ART MODIFICATION NOTE 19, REVISION A (for Electronics Technicians)

**SUBJECT** : Removal and Disposal Instructions for the ART-2 Transformer Chassis Assembly and ART-1/2 Ranging Unit Transmitter/Comparator System

**PURPOSE** : Remove and dispose of polychlorinated biphenyls (PCB) in the ART-2 Transformer Chassis Assembly and the ART-1/2 Ranging Unit Transmitter/Comparator System.

**Figure 3.** Transformer Chassis Assembly (rear view)

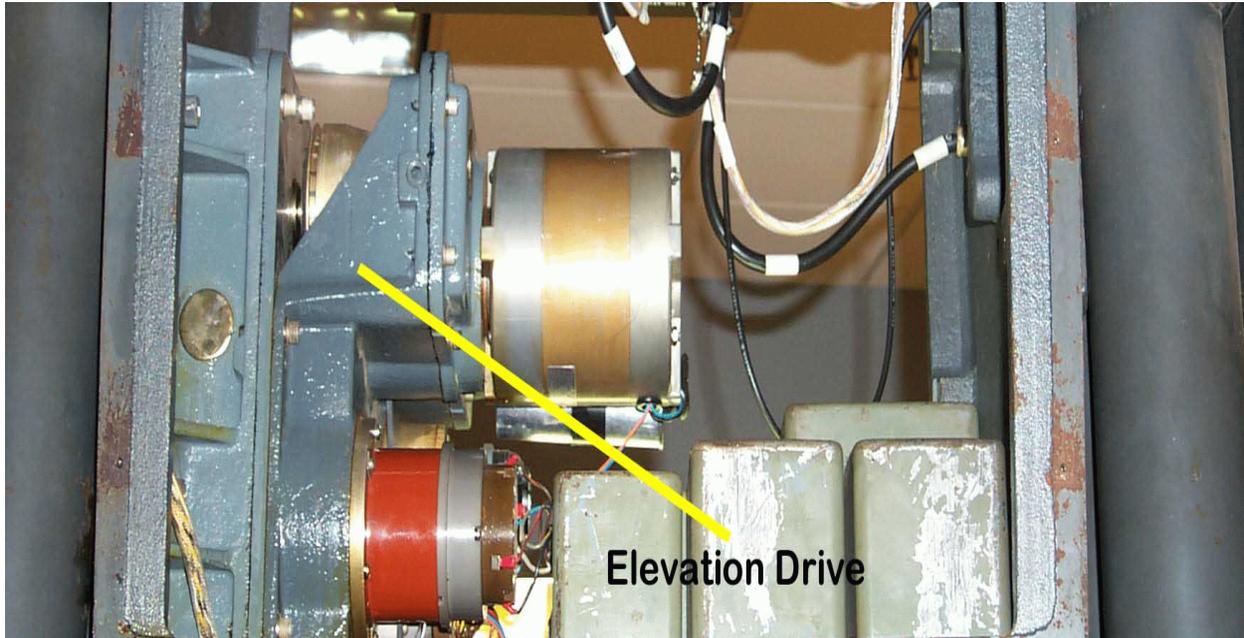
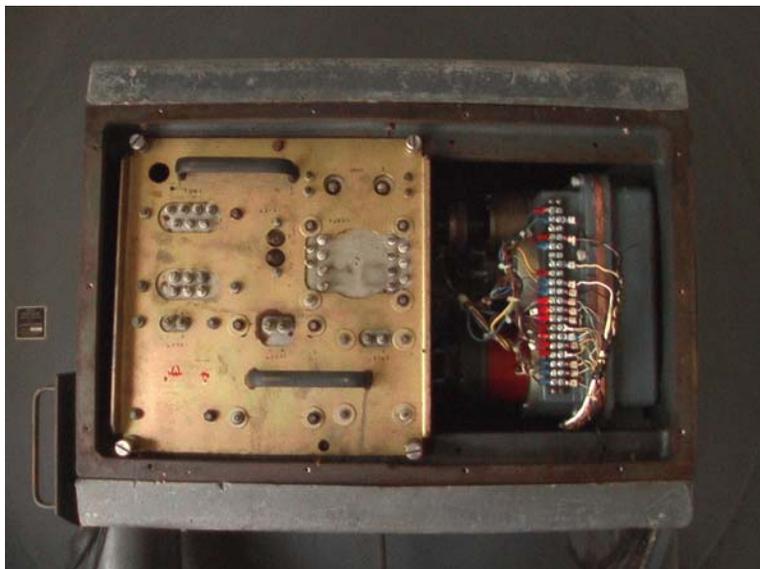
- e. Remove the four thumbscrews (save screws for replacement) from each corner of the Transformer Chassis Assembly (see Figure 3).

- f. **(Requires two people.)** With one person on each side holding on to one of the front panel handles, lift and remove the Transformer Chassis Assembly from the elevation assembly and carefully lower it to the floor. Tilt the unit to clear the bolt and nut (next to bottom left transformer chassis screw) attaching the lead weights to the Elevation Housing Assembly (see Figure 4).
- g. **(Requires two people.)** With one person on each side holding on to one of the front panel handles, carry the unit down the UAIB stairs and carefully set it on the ground next to the steel drum.
- h. Initiate the disposal procedure in accordance with Section F, paragraphs 7 and 8 (page 17).

**Figure 5.** Transformer Chassis Replacement Plate

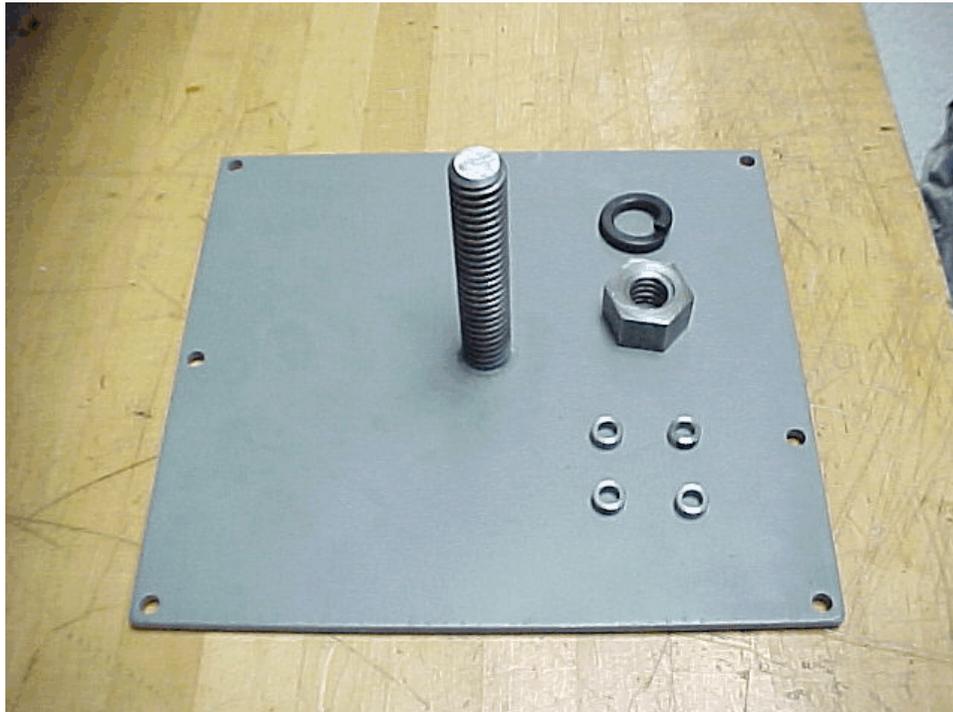
2. Install the Replacement Plate and Weights Kit as follows.
  - a. Ensure the Antenna Assembly is at 0 degrees elevation and locked in position.
  - b. Put a lubricating oil (WD-40) in each of the four thumbscrew holes and on the thumbscrew bolt threads.
  - c. Lift and align the replacement plate to the exact place of the previous Transformer Chassis Assembly (with center rod facing inside the elevation housing). Ensure the two plate alignment holes are located over the two holding pins (see Figure 5).

- d. After aligning the new plate on the elevation housing, pull the new plate back slightly from the housing. Put the 4 spacers on the 4 screws that were removed from the Transformer Chassis Assembly. To ensure proper screw alignment, insert all four screws half way into the holes while the plate is pulled back from

- the housing. Then tighten each screw evenly, progressing in a clockwise rotation.
- e. Unlock the antenna and manually slew the Antenna Assembly to 90 degrees.
  - f. If the top cover (1A2A2A10) of the elevation housing has not already been removed, loosen the 14 captive screws and remove it.
  - g. Place one of the 10-lb weights over the center rod of the replacement plate; then place the two 25-lb weights followed by the other 10-lb weight.
  - h. Place a lockwasher and nut on the rod to hold the weights tight. Use a 15-inch crescent wrench to firmly tighten the nut until the lockwasher is fully compressed (see Figure 6).
